STAFF REPORT - TOWN OF NORTH CASTLE PLANNING DEPARTMENT

APPLICATION NAME & NUMBER
 121 Lafayette Ave [2021-023] – Site Development
 Plan for Rooftop Solar

76 panel 32.68 kW rooftop mounted solar system with roof addition.

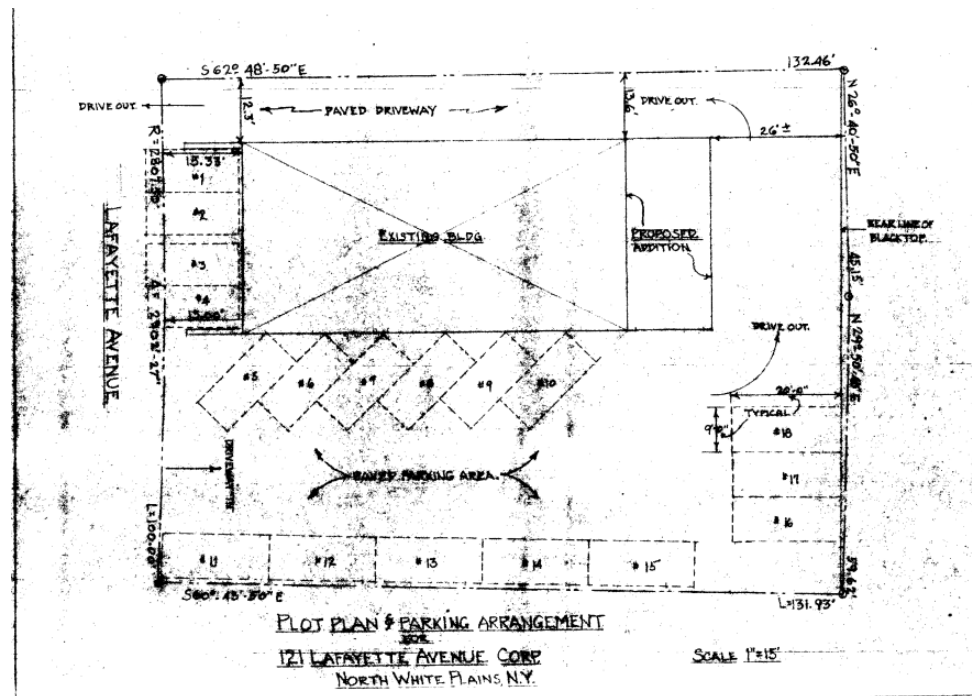
1. The submitted site plan depicts the property being used as an office and warehouse. It is noted that the Planning Department does not have any site plan approval for this site on record. Documentation in the Building Department indicates that the site was formerly an office building.

It appears that the off-street parking required for 121 Lafayette Ave is to be provided on 123 Lafayette Ave per documents in the Building Department files. However, it appears that 123 Lafayette is being used as a landscaping/contractor's yard.

2. The site plan have been revised to add the 119 Lafayette property to the 121 site plan. The Applicant should explain whether the Applicant is proposing to merge the two lots at this time. If not, the site plan should be revised to depict the boundaries of each lot. If the Applicant is proposing to merge the two lots, the site plan will need to be updated to depict existing and proposed uses at 119 Lafayette Ave and update the off-street parking chart to include all uses and required parking for 119 Lafayette Ave. If the lots are to remain separate, the Applicant will need to demonstrate that the proposed 121 Lafayette Avenue parking on 119 Lafayette Ave is in excess of what is required at 119 Lafayette Ave and provide a legal instrument, satisfactory to the Town Attorney, assuring the continued existence and use of said parking spaces in connection with the land uses and structures they serve, pursuant to Section 355-56.A(2) of the Town Code.

3. The site plan depicts a yard area that appears to conflict with the proposed off-street parking spaces. The Applicant should clearly delineate the proposed yard area on the site plan.

4. The site plan depicts an outdoor yard area, temporary bins for organic recycling and outdoor materials and storage. The Town Code permits the proposed outdoor uses only when determined by the Planning Board as accessory and essential to a permitted use and only when such storage areas do not exceed 15% of the lot area, are suitably screened and are approved by the Planning Board as to location and screening.

5. The Applicant is proposing a roof addition (overhang) for additional solar panels. The Applicant should submit a site plan depicting the location of the roof addition in relation to the property lines. The plan shall also contain a zoning conformance table.

6. The Applicant should submit a proposed building elevation depicting the roof modifications. The elevation should clearly depict the height of the proposed roof addition over the driveway. The Applicant should demonstrate that the proposed roof addition would not preclude vehicles and trucks from utilizing the driveway.

7. It is not clear whether the proposed SunShield Awning would be permitted as Chapter 258 requires all rooftop mounted solar to be flush mounted to the roof. The Applicant should confirm that the SunShield will only be utilized over the driveway at that the balance of the solar installation will be flush mounted.

The Building Department will need to confirm that the current uses on the site are permitted and that there are no current issues regarding the existing use of the property.

The Applicant should provide additional clarity to the Planning Board regarding off-street parking provisions for this lot.

The Building Department should determine whether the utilization of the SunShield would be permitted.
